July 31, 2023

**Re: Application for Zoning By-Law Amendment D14-2023-007
Response to CRCA Comments**

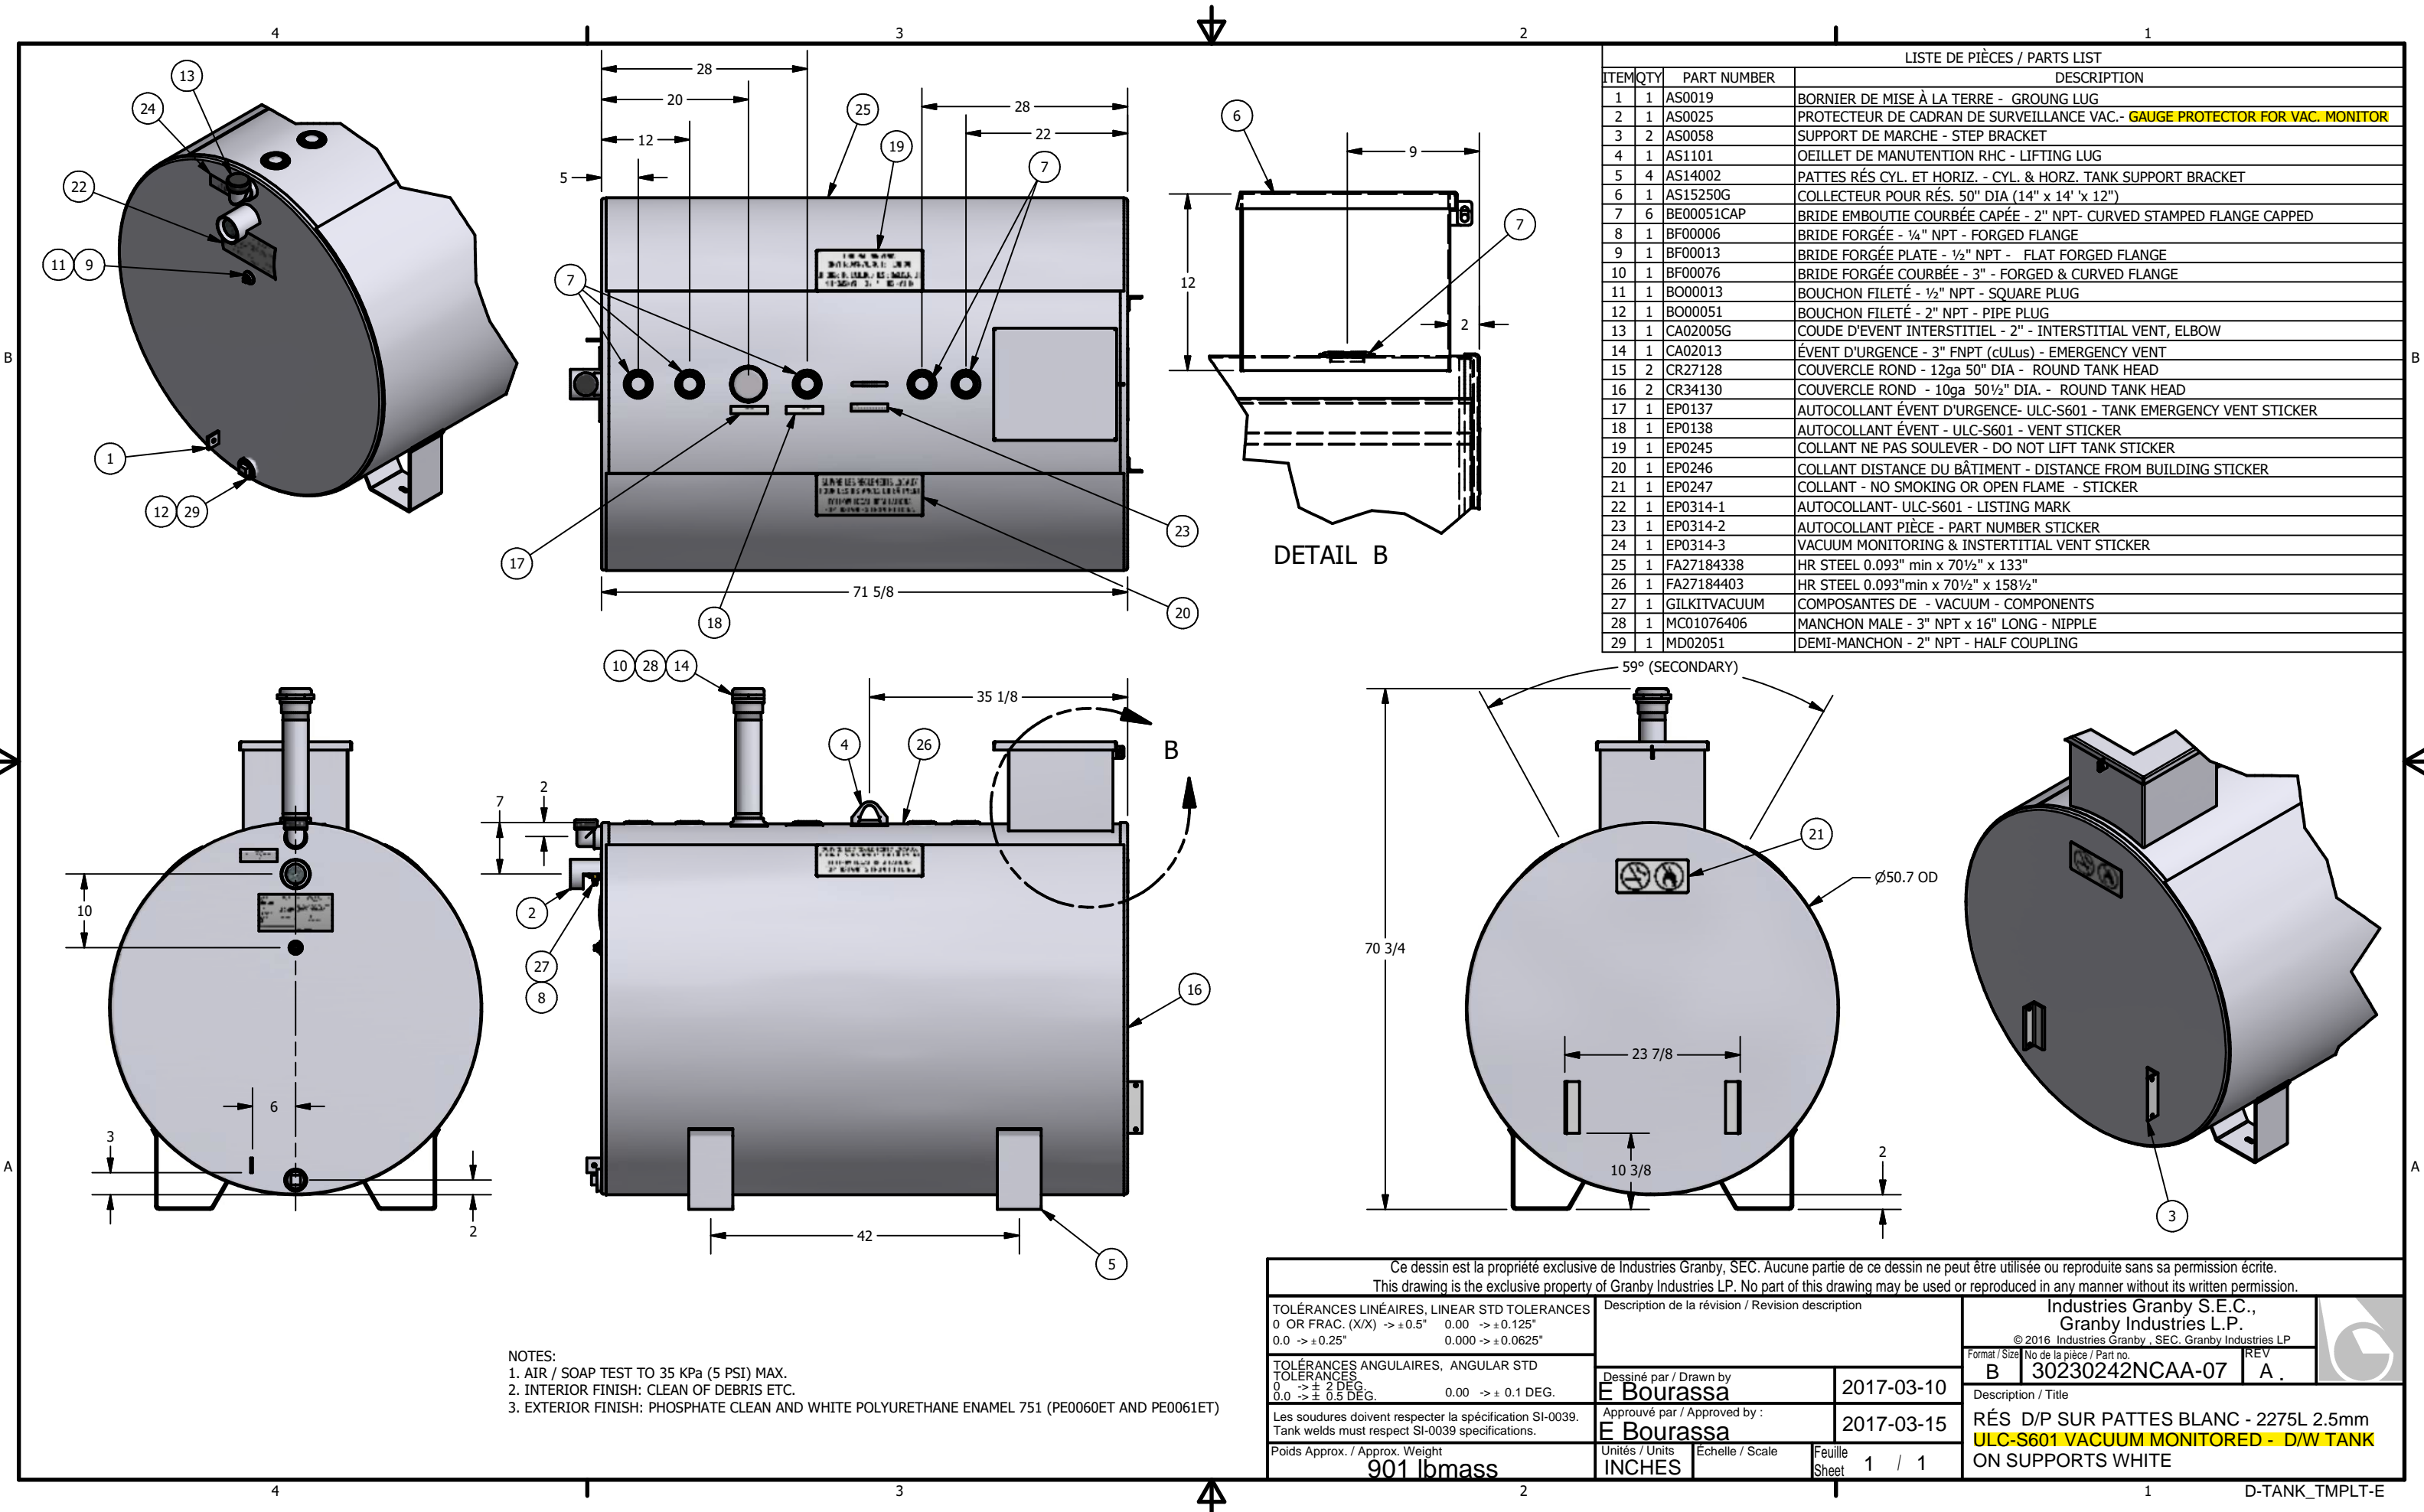
- ii. Liquid Fuel: There are a number of fuel tanks on site, used to refuel equipment on a regular basis for use in the marine construction business. KMC has provided specification details for the fuel tanks on the property. This information is included in Attachment A. The tanks are double walled tanks with a vacuum monitoring system to identify any potential tank leak. The redundancy of the double tank wall and the vacuum monitoring provides for advanced warning of a potential spill/leakage risk with opportunity to address the risk.
